ECO UGEMC 01-04-2008

“Filter Capacitor on 29 V power supply”

ECO UGRS232 01-09-2008

“ UGSCM RS232 connections”

Fig 2. RS232 Rx lines scheme after changes

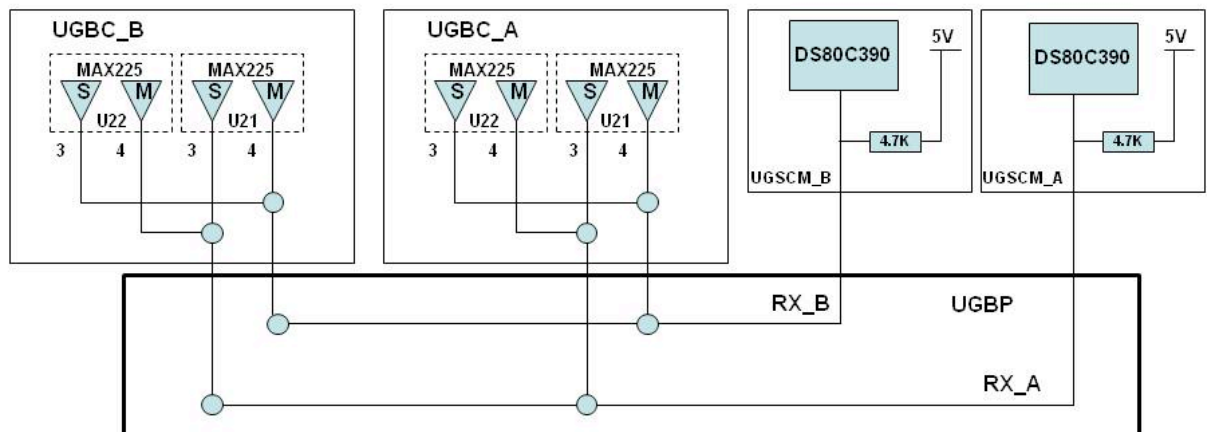
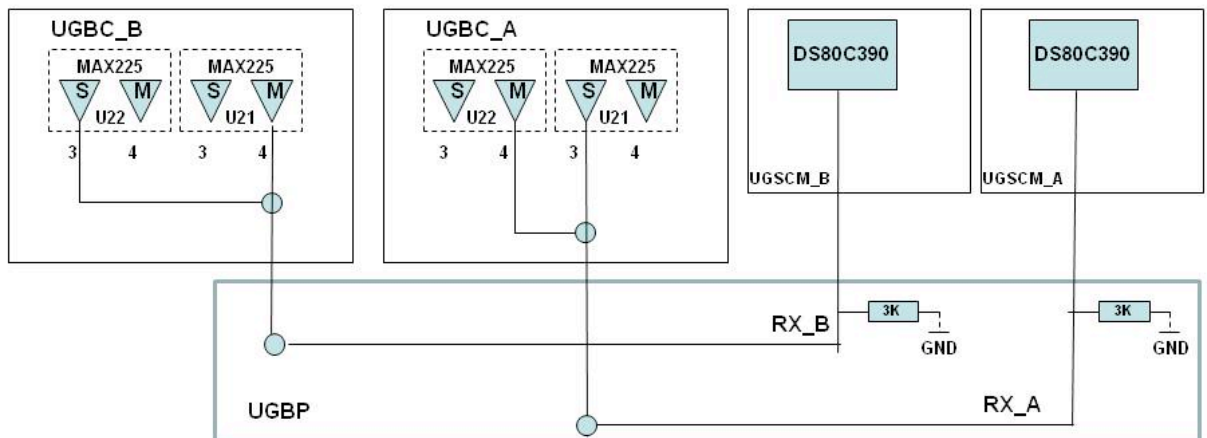
A problem was found on RS232 RX lines connecting UGBC-A (Hot) and UGBC-B (Cold) cards to UGSCM-A and to UGSCM-B cards.

When UGcrate A side is on, 5.6 Volt-A power supply propagates to 5.6 Volt-B power supply line through RS232 driver/receiver chips (MAX225) located on UGBC-B and vice versa.

The cause of this behavior is that UGBC-A and UGBC-B shares the RX lines to be able to communicate via RS232 with both UGSCMs.

The problem can be solved avoiding RX lines sharing and connecting, through RS232, UGBC-A with UGSCM-A and UGBC-B with UGSCM-B only.

Since both UGSCMs are powered by both 5.6 Volt-A and 5.6 Volt-B is also necessary to change the RX lines “pull-up” resistor with “pull-down”.

UGBC-A : Chip U21 disconnect from PCB pins 4 and 21, Chip U22 disconnect from PCB pins 3 and 22

UGBC-B : Chip U21 disconnect from PCB pins 3 and 22, Chip U22 disconnect from PCB pins 4 and 21

UGSCMs : Remove “pull-up” resistor R2

UGBP : Insert a 3000 Ohm ¼ Watt “pull-down” resistor on RX0_A signal and on RX0_B signal

Fig. 4 RS232 TX lines after changes

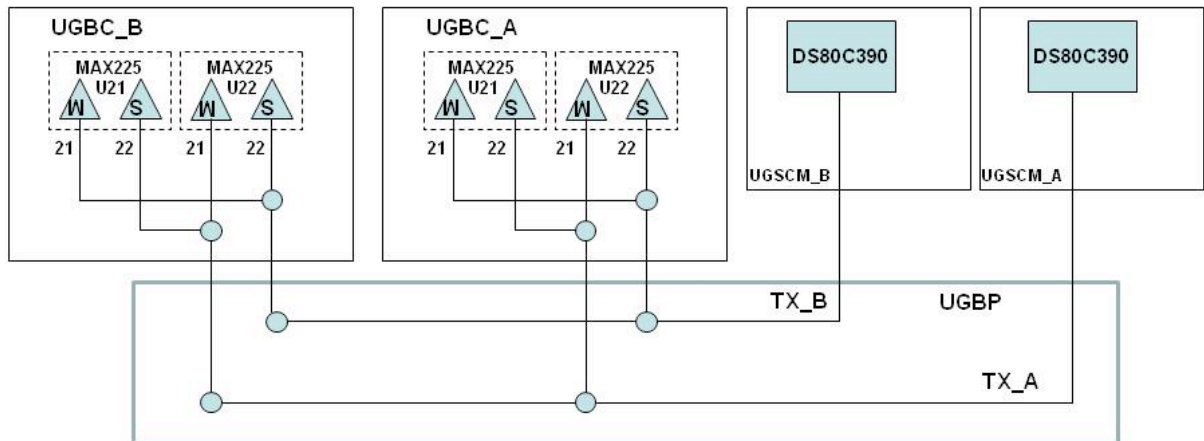
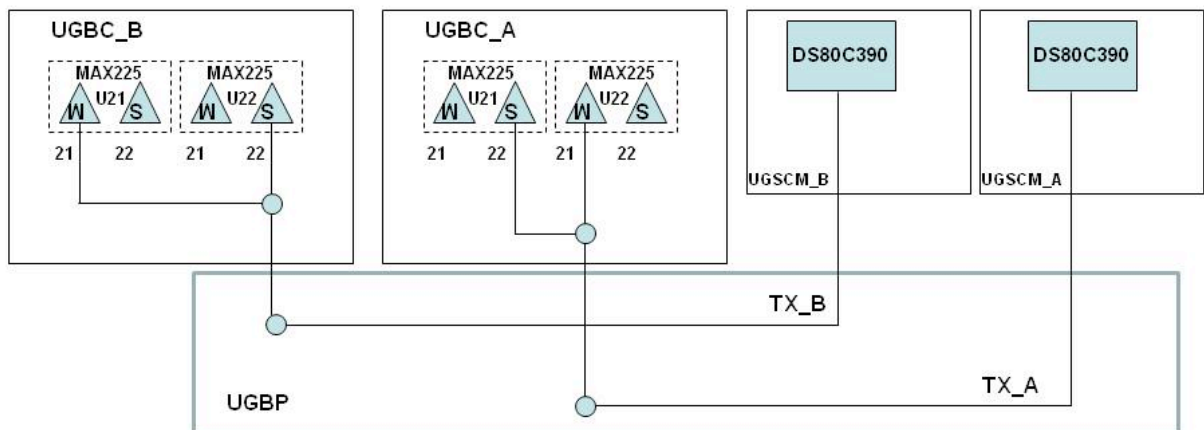
Such changes implies that corresponding RS232 TX lines are no needed.

Fig. 1 Changes on Lecroy bus data lines on UGBP

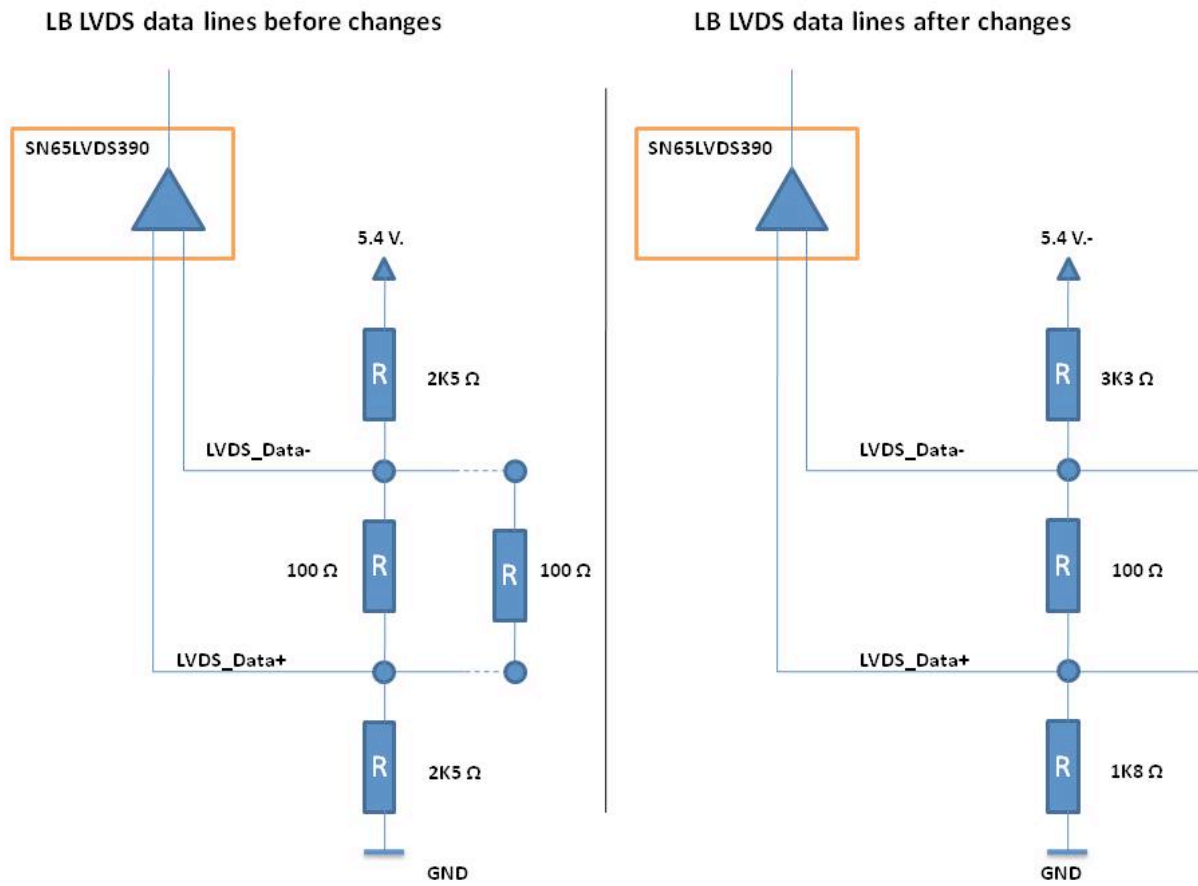
LB data signals “pull down” resistors, soldered on the backplane, produce a bias voltage value at the input of LVDS receivers (SN65LVDS390PW) that exceed specifications.

The consequence is instability of the LVDS receiver’s outputs when any card is not driving the bus.

Further the LB data signals (used for bidirectional communication) are terminated using 2 100 Ohm parallel resistors between the two differential signals (+ and -) located on the UGBP one at the start (UGSCM slot) and one at the end (UGxx slot) of the bus. This solution is not compatible with the LVDS technology selected if the described pull down is adopted.

The problem can be solved by changing the resistor values so that the bias voltage produced is compliant with the specifications.

3300 Ohm for R41, R42, R43, R44

1800 Ohm for R31, R32, R33, R34

While termination resistors at the UGSCM slot side R01, R02, R03, R04 are removed.

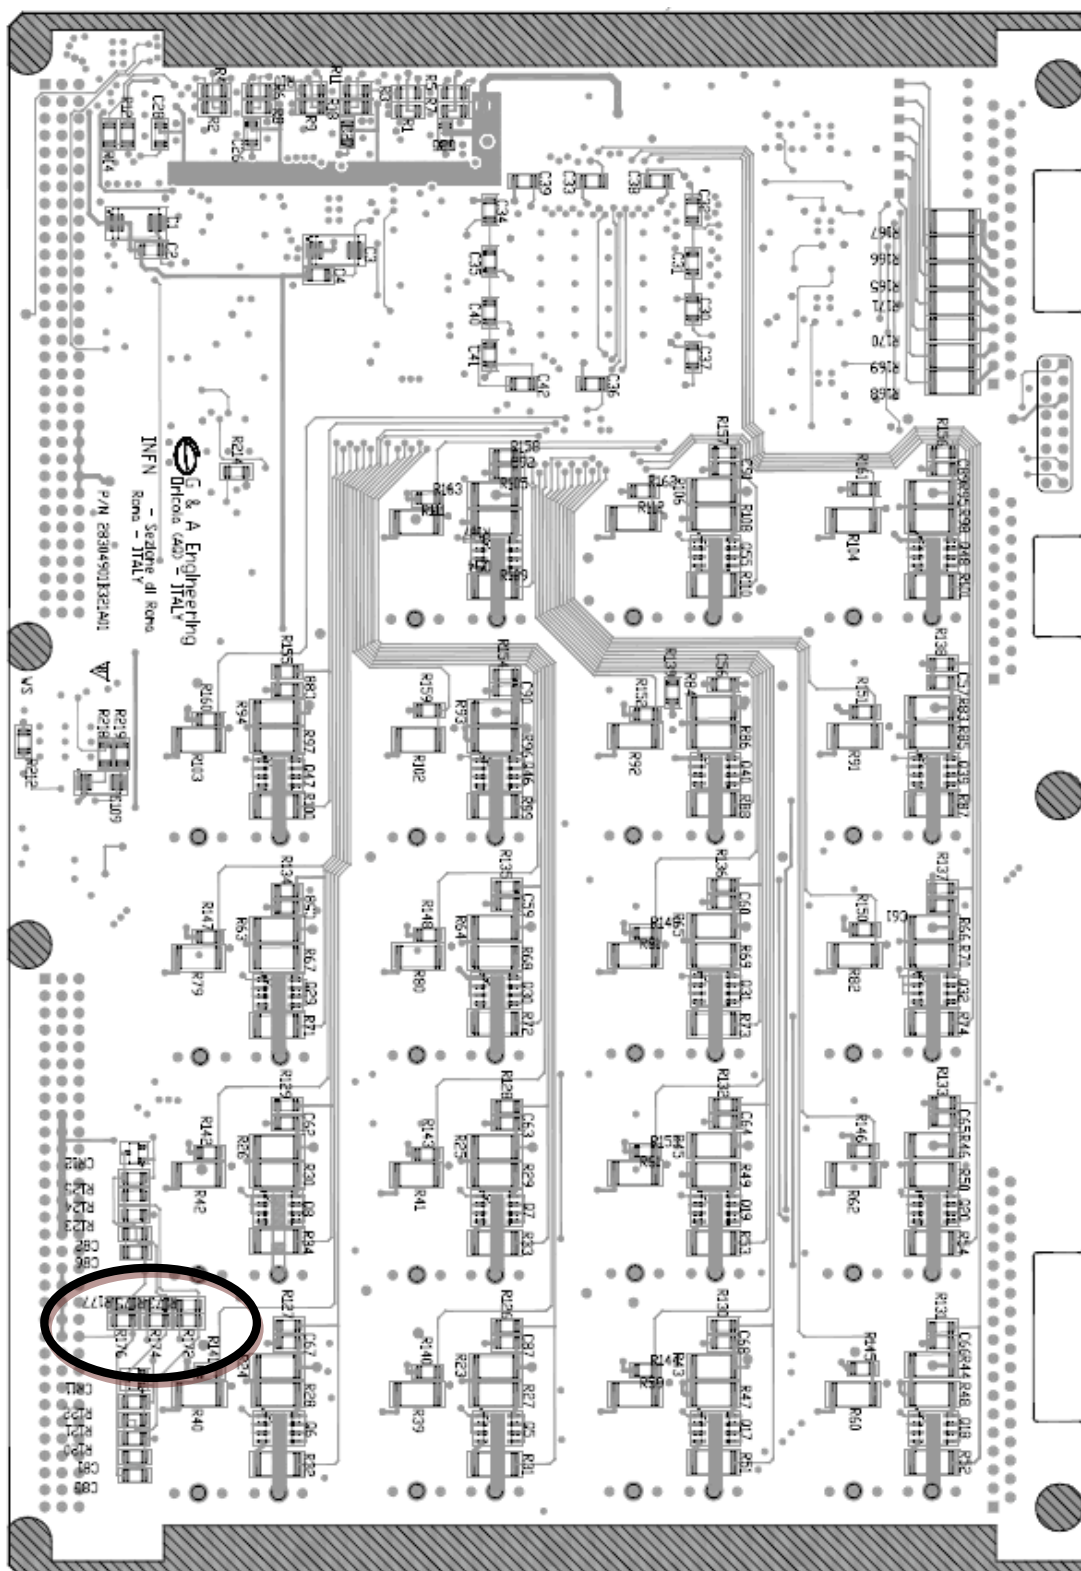
A different configuration of jumpers connecting UGSCM “dallas sensors” chain n.8 to UGBS JS2 connector is needed to comply with the actual TRDGAS cabling.

Such jumpers are implemented using six 0 Ohm resistors located on UGBS.

The new configuration is obtained changing the jumper configuration on some QM2, FM and FS UGBSs in the following way:

Remove three resistors on UGBS s/n 002 and 004 (BOM descriptors) :

R173, R175, R177 (see next page)

Mount three resistor (type RESTKSFM140R00) on UGBS s/n 002 , 004 and 005 (BOM descriptors):

R172, R174, R176 (see next page)
